PPA Comments on South Jersey Gas pipeline, January 24, 2017

# South Jersey Gas Pipeline Review:

Analysis of Likely Actual Use of Proposed South Jersey Pipeline by BL  
England Plant and Assessment of Excess Capacity Available to Serve  
Customers Primarily Outside of Pinelands

Pinelands Preservation Alliance

Table 1: South Jersey Gas 2013 Presentation

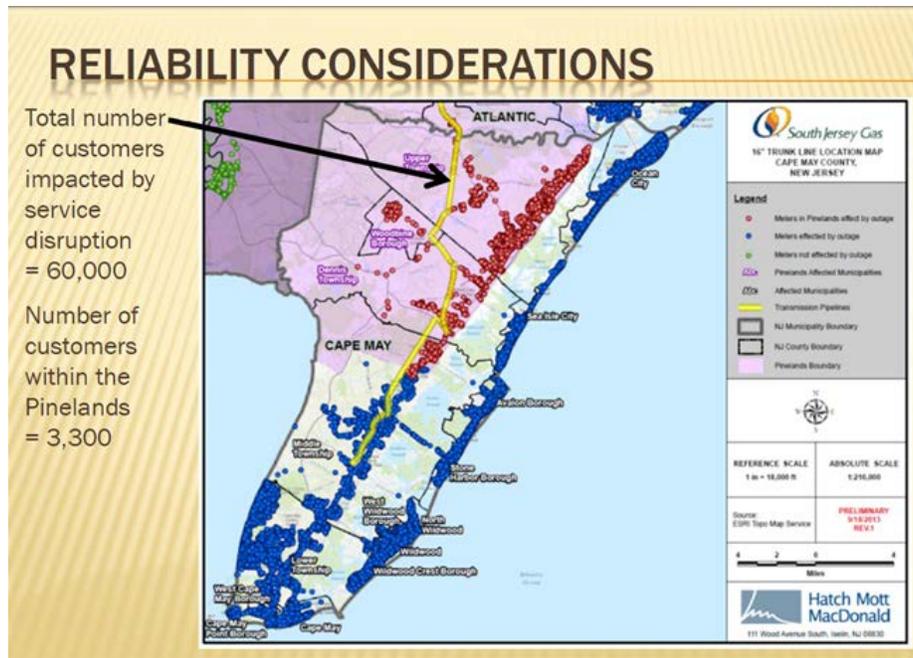
It is important to note here also that, as will be discussed below, SJG customers within the Pinelands near or south of the Interconnect Station are far fewer (i.e., 5.5% or 3,300 per SJG) than the overall 60,000 SJG customers within the area cited by SJG in the 2013 presentation (Figure 1 shown below)<sup>14</sup>.

While SJG has stated that the proposed route can support both Cape May County to the south and Atlantic County to the north, this is not true given the current state of the SJG system in that area. To the north of the Interconnect Station along the North-South line, that 250 psi line connects to a line of higher pressure (350 psi). A 250-psi line simply cannot feed a 350 psi line absent a substantial operating pressure reduction of the higher pressure line. This means that, absent a future upgrade of the North-South Line to the north of the Interconnect Station, no assurance of providing either reliability or redundancy can reasonably be made.

Table 2: South Jersey Gas 2013 Presentation

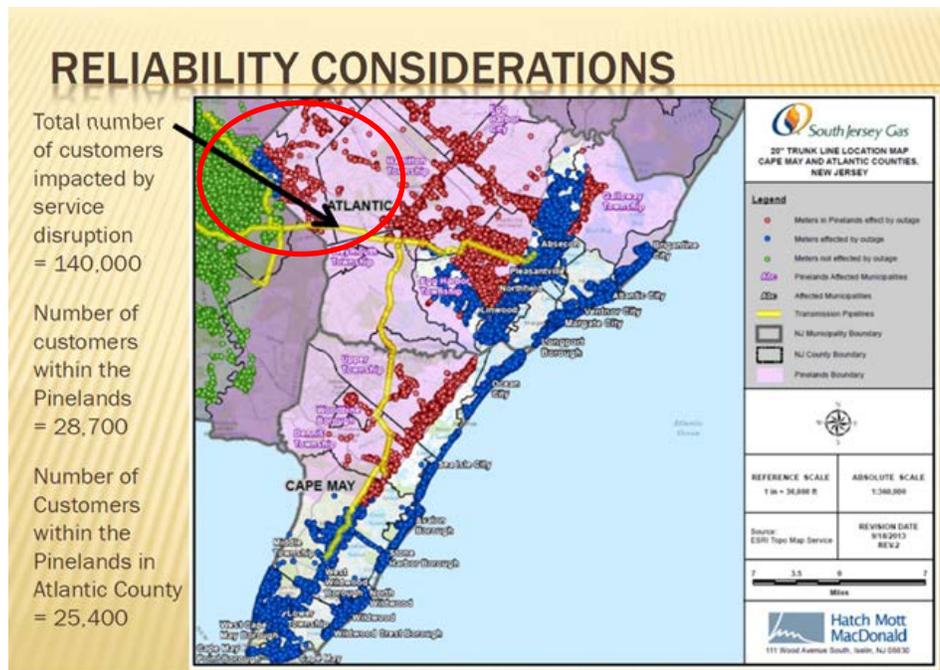
In Figure 2 (pasted below, as modified by Skipping Stone), SJG states that there might be an additional 80,000 customers (140,000<sup>15</sup> customers in total including the 60,000 previously discussed) impacted by a service disruption impacting Atlantic and Cape May Counties, of which SJG states that 28,700<sup>16</sup> (~20% ) reside in the Pinelands.
